**Bartlett Regional Hospital Emergency Department Ventilation Upgrades
Contract No. BE22-037**

ADDENDUM NO.: TWO

DATE ADDENDUM ISSUED: July 29, 2021

A-404

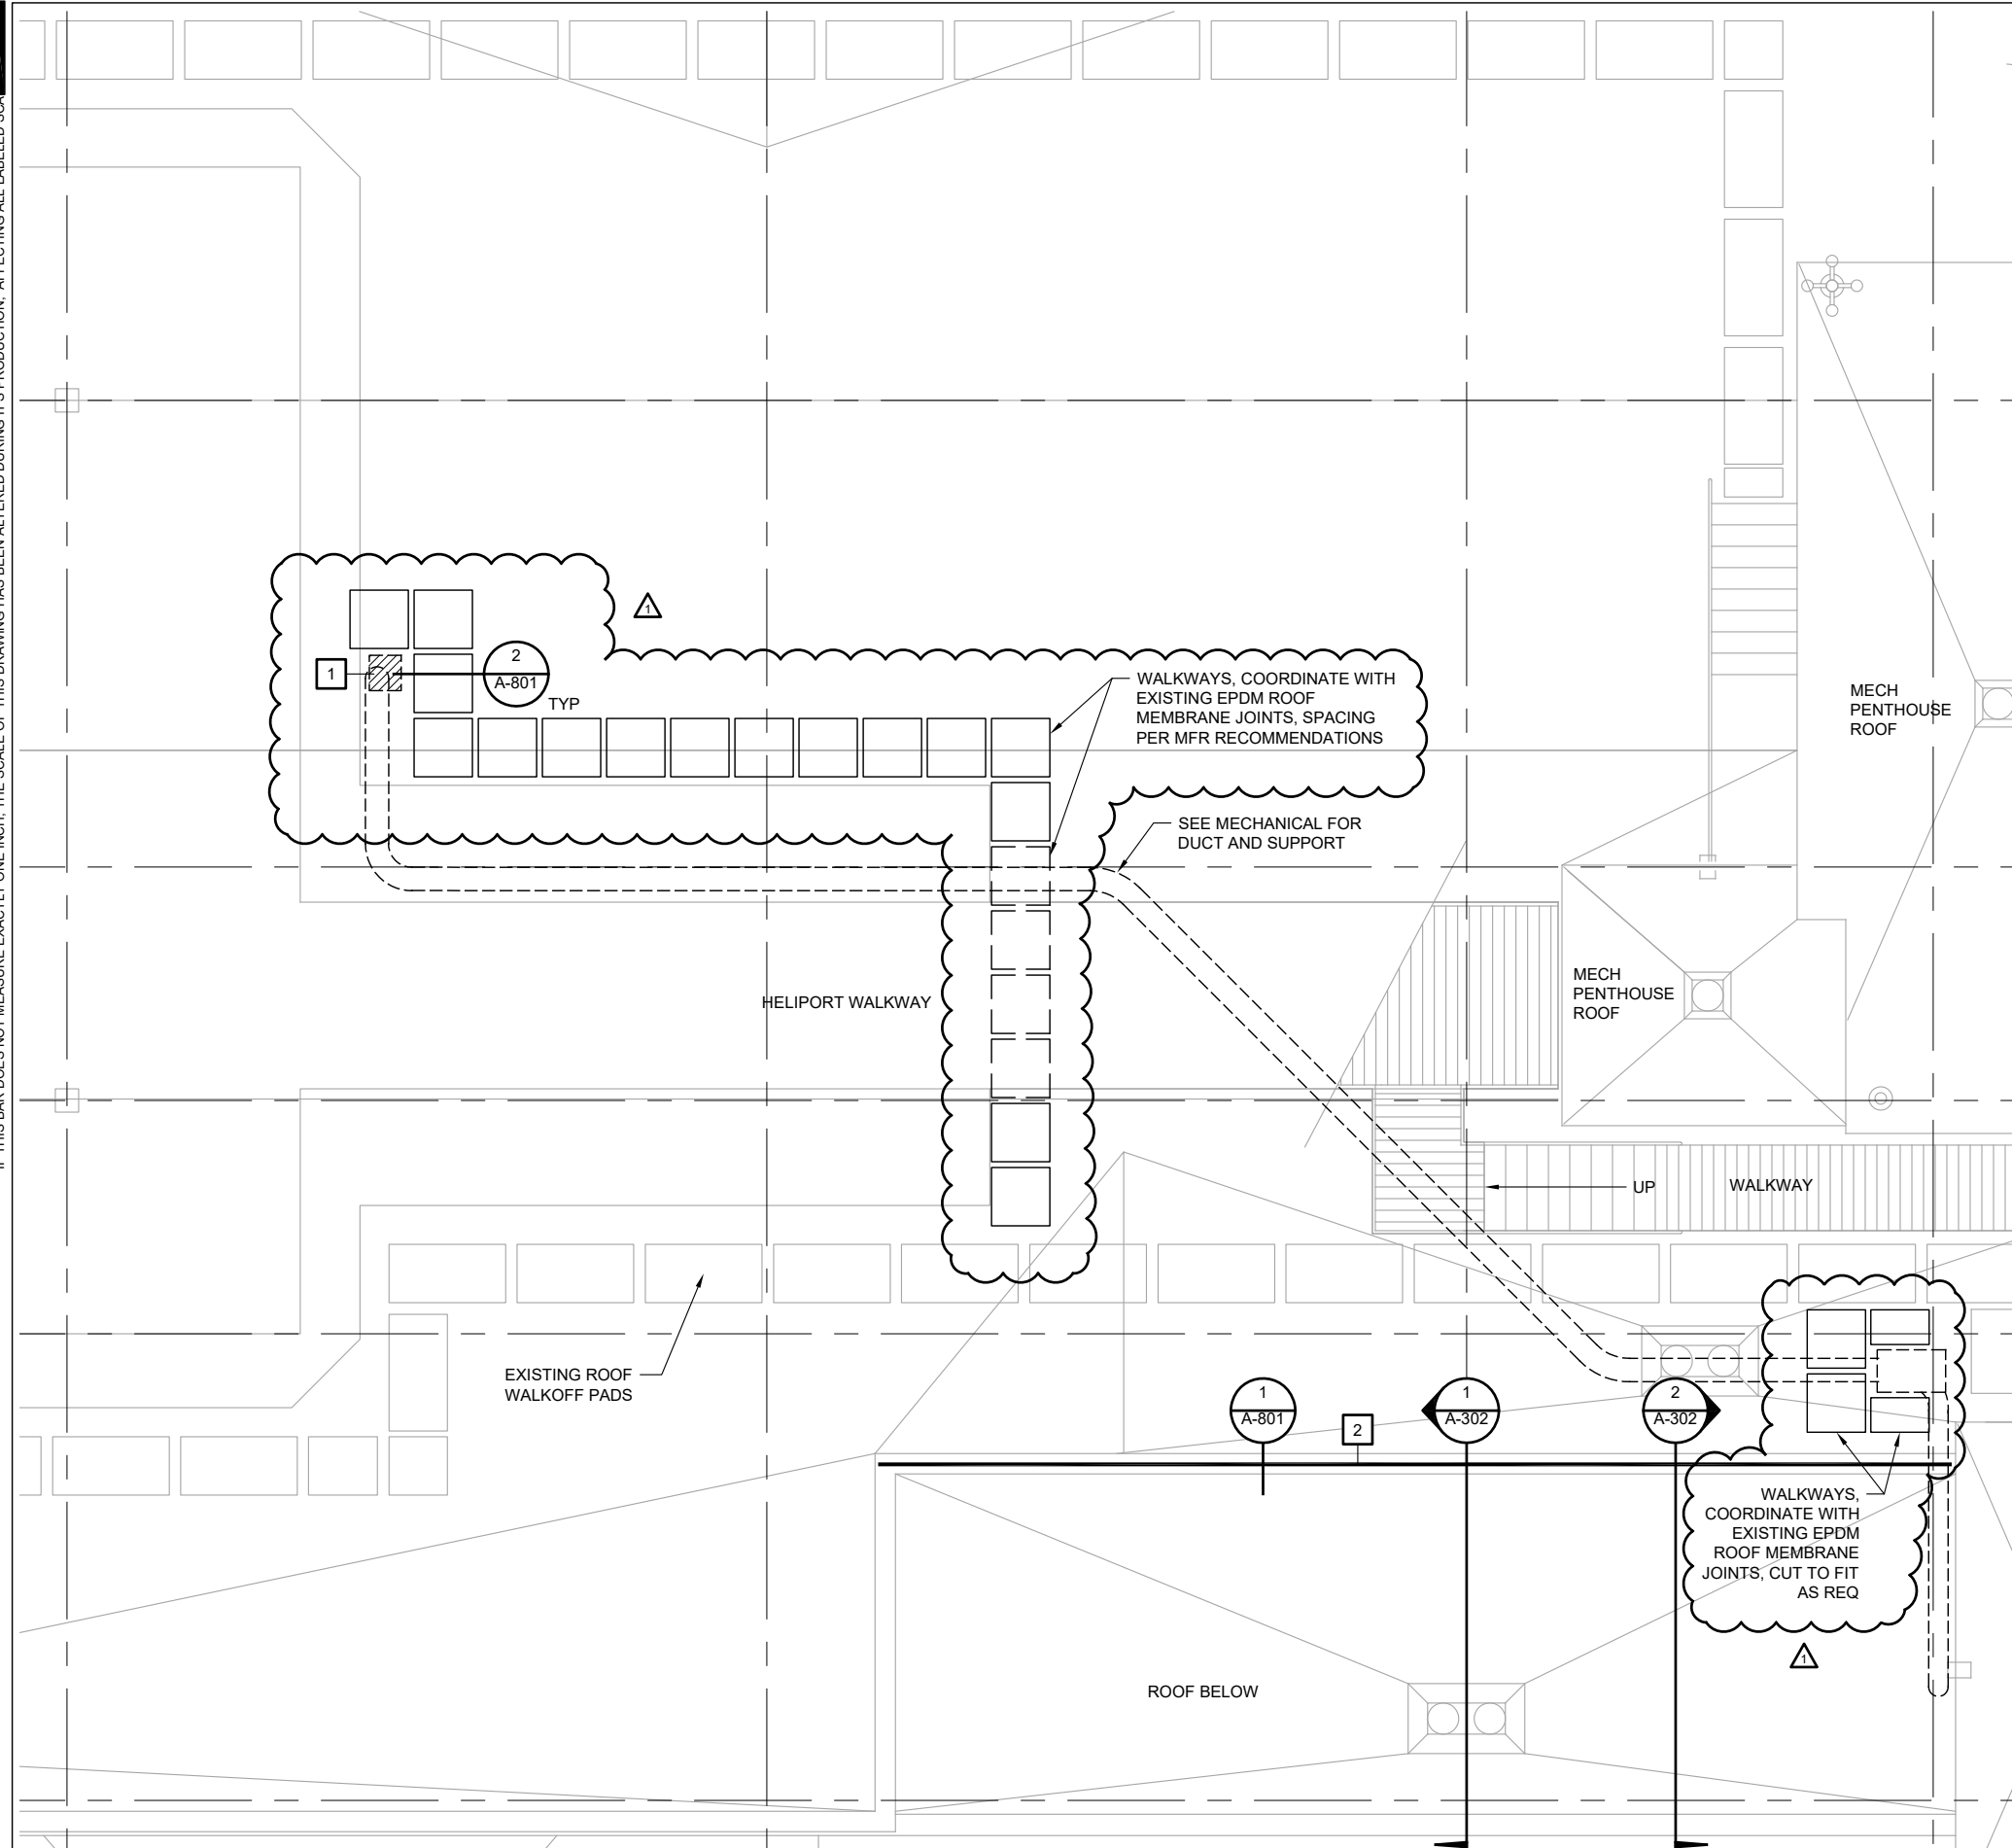
Item No. 14 PLAN SHEET A-404, SHEET KEY NOTES, KEY NOTE 1, **add** the following:
"COORDINATE CONCRETE ROOF PENETRATION WITH EXISTING IN-SLAB ELECTRICAL CONDUITS AND OTHER UTILITIES TO AVOID DAMAGING ANY IN-SLAB ELECTRICAL OR OTHER UTILITIES. CONTRACTOR IS RESPONSIBLE FOR DAMAGE AND REPAIRS TO ANY INSLAB UTILITIES."

- 1 SAW CUT OR CORE CONC ROOF DECK FOR MECH WORK, PATCH CONC SLAB AS REQ, COORDINATE CONCRETE DECK PENETRATIONS AND SIZE FOR EXHAUST DUCT WITH EXISTING INSLAB REINFORCEMENT TO AVOID CUTTING REINFORCEMENT BARS, CUT AND PATCH ROOF AS REQ'D FOR MECH WORK. SEE ROOF CURB DETAIL, EXISTING CONCRETE VARIES, SEAL DUCT PENETRATIONS AT 2HR FLOOR FOLLOWING HILTI C-AJ-7084 WITH FS-ONE MAX AND MINERAL WOOL PACKING MATERIAL, COORDINATE CONCRETE FLOOR PENETRATIONS WITH EXISTING IN-SLAB ELECTRICAL CONDUITS AND OTHER UTILITIES TO AVOID DAMAGING ANY IN-SLAB ELECTRICAL OR OTHER UTILITIES. CONTRACTOR IS RESPONSIBLE FOR DAMAGE AND REPAIRS TO ANY INSLAB UTILITIES
